Notice of Meeting
Polk City | Planning and Zoning Commission (P&Z)

June 21, 2021 | 6:00 pm

**AMENDED PRELIMINARY DEVELOPMENT PLAN,
 PRELIMINARY PLAT AND SITE PLAN REVIEW**

Compiled by: Kathleen Connor, Planner

DATE: _____
 REVISIONS: _____
 3405 S.E. CROSSROADS DRIVE, SUITE G
 GRIMES, IOWA 50111
 PHONE: (515) 369-4400 FAX: (515) 369-4410
 ENGINEER: _____
 TECH: _____
WOLF CREEK TOWNHOMES PLAT 13
GRADING PLAN
5.0
 2006.287
 POLK CITY, IOWA
 CIVIL DESIGN ADVANTAGE

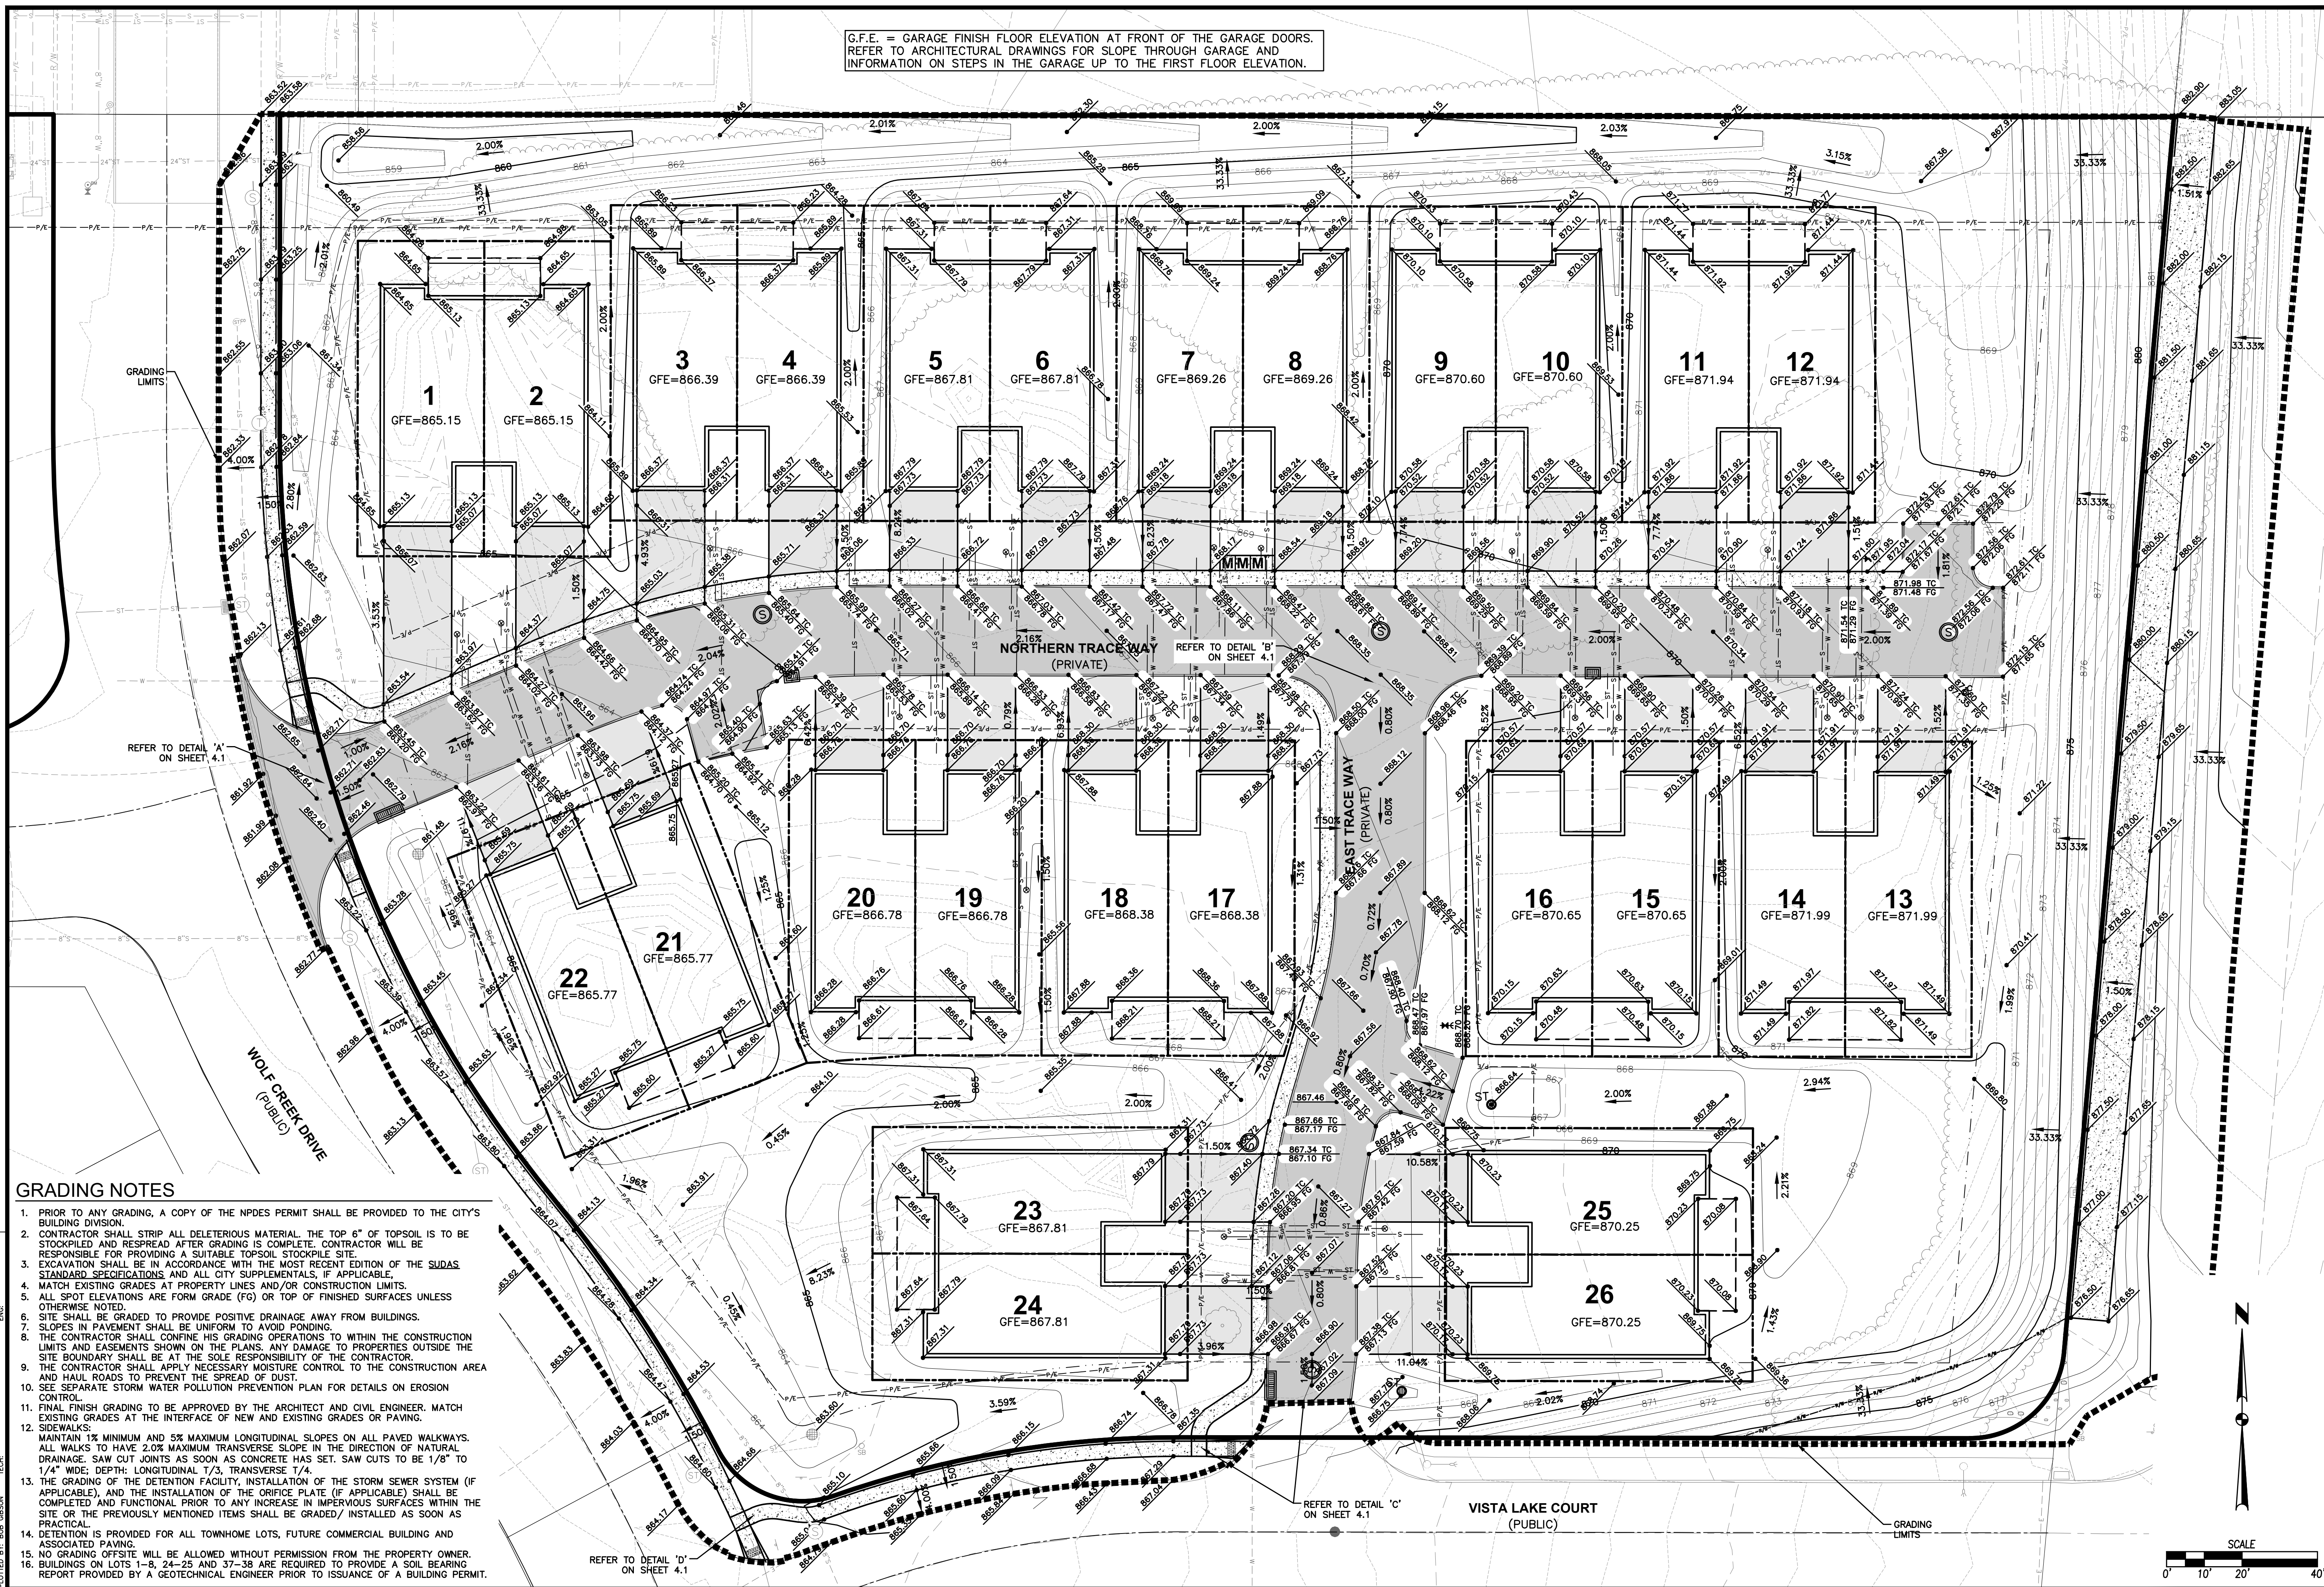
3. Provide AutoCad TIN data file to Snyder & Associates so grading can be coordinated between the roundabout, sidewalk/trail, relocated monument sign, and site improvements. Update grading plan accordingly. As-built grading in this area will be provided on the Record Drawings for public improvements.

LOCATION: POLK CITY DOLLAR FRESH  
E 3RD ST & W BRIDGE RD

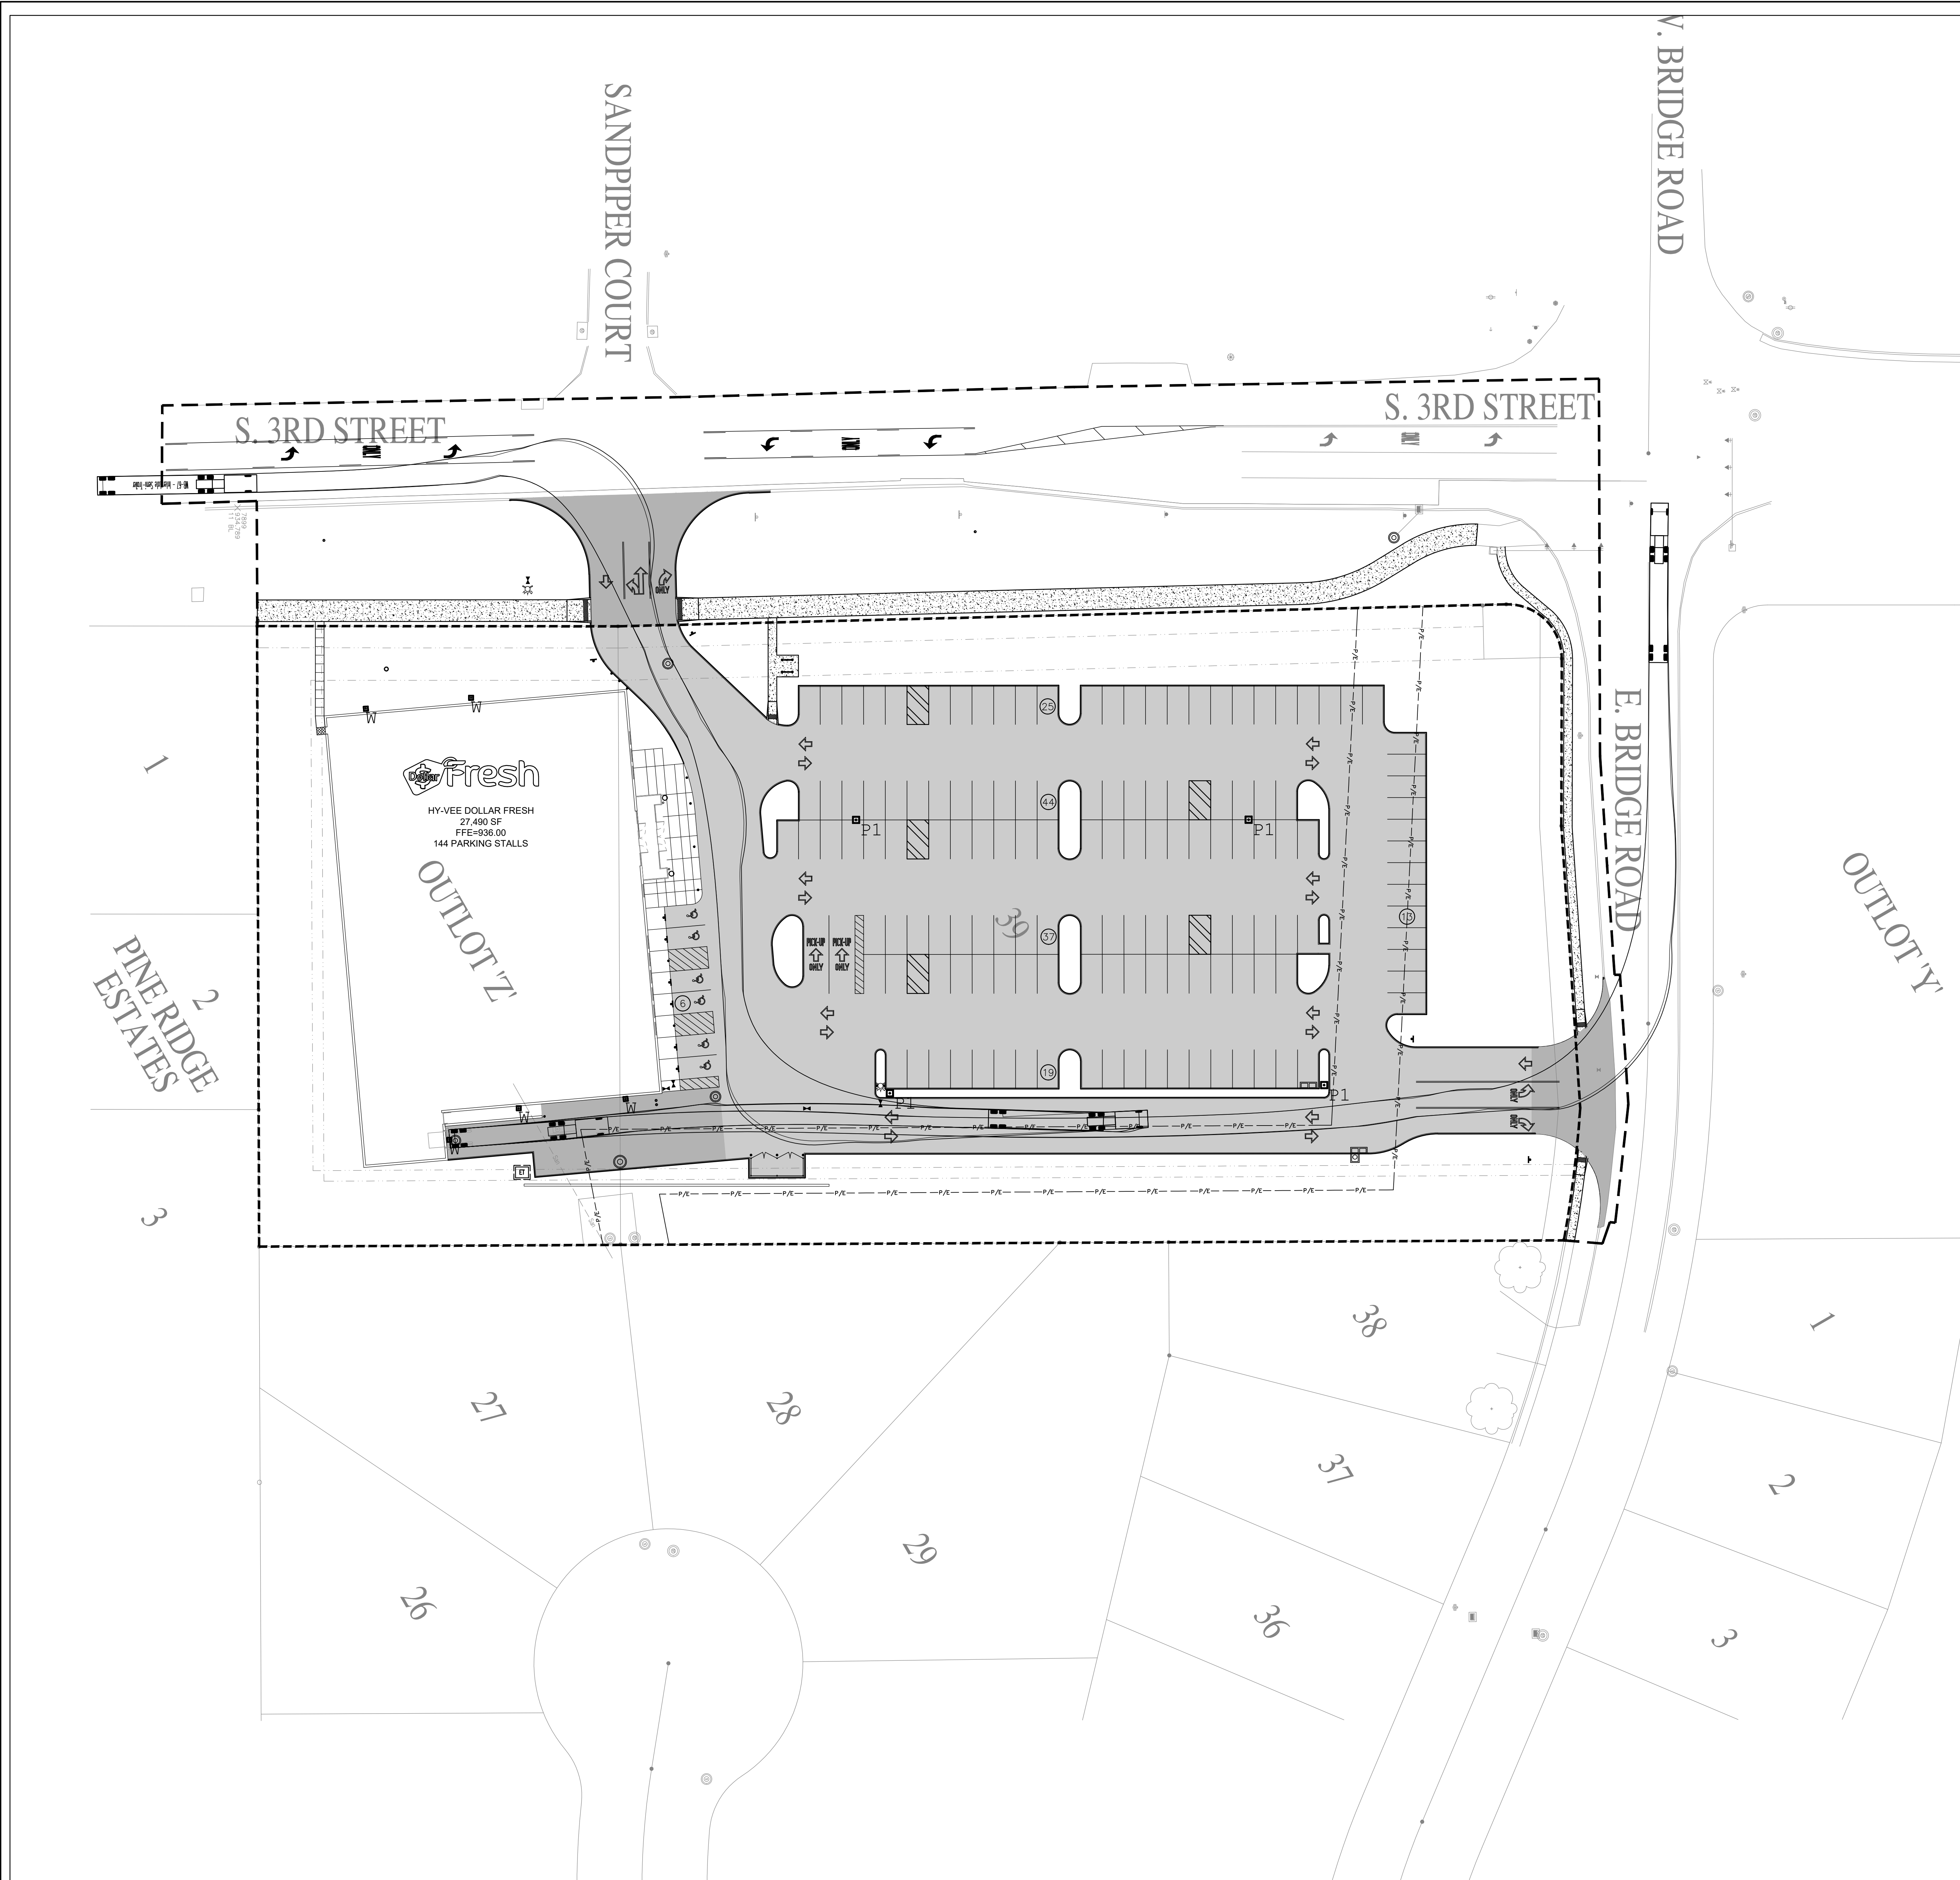
1. Provide a revised Traffic Impact Study for review and approval that addresses all of Snyder & Associates prior review comments as well as the comments provided by Iowa DOT. The TIS will need to be approved by Iowa DOT prior to Site Plan approval.
2. Provide revised easement plat, vacation plats, and legal descriptions as per our review comments emailed on 6/16/21.
3. Add a note to the Cover Sheet stating "Traffic-related Public Improvements shown on S. 3rd Street are for illustration only. Actual public improvements shall be in accordance with the

Construction Drawings for Public Improvements as approved by City Council and Iowa DOT.”
Revise Note 11 on Sheet C2.0 accordingly.

SHEET  
**C2.1**

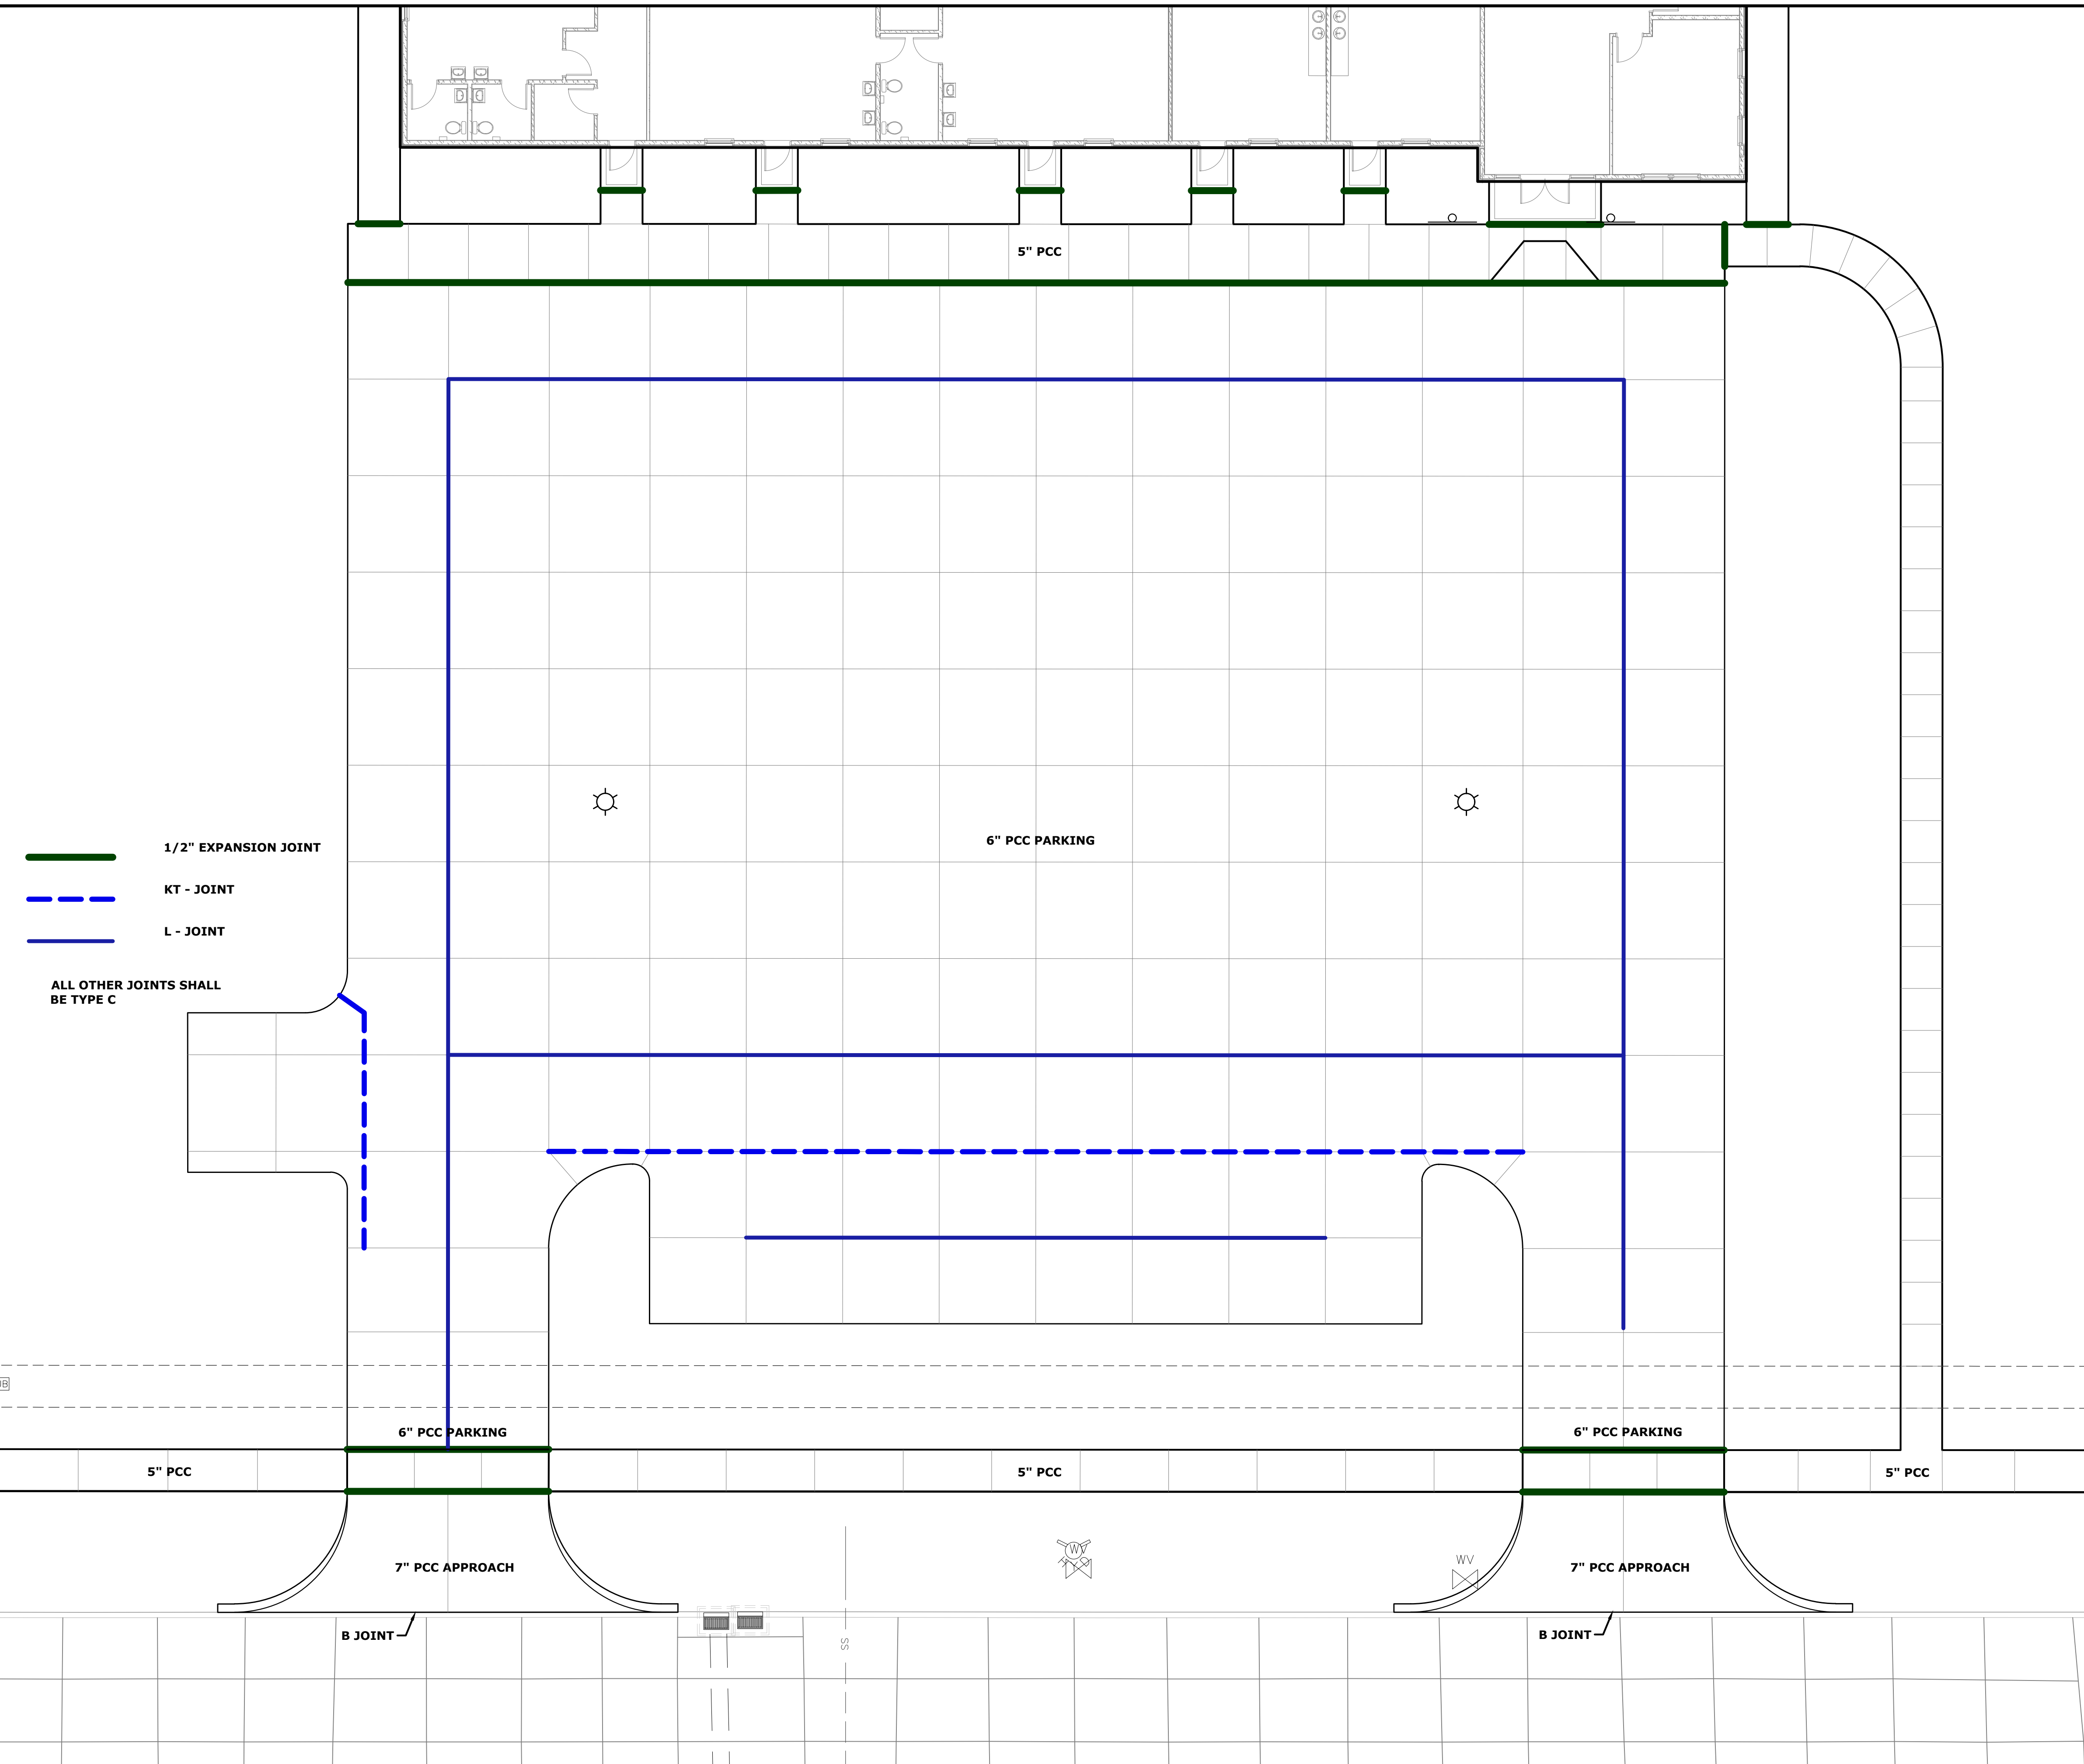
7. Since there is no note or color differentiation between the 6" PCC and 7" PCC, it is not clear the trail/sidewalk across driveways will be 7" thick. Add a note or other means to clarify this pavement thickness on Sheet C2.1.
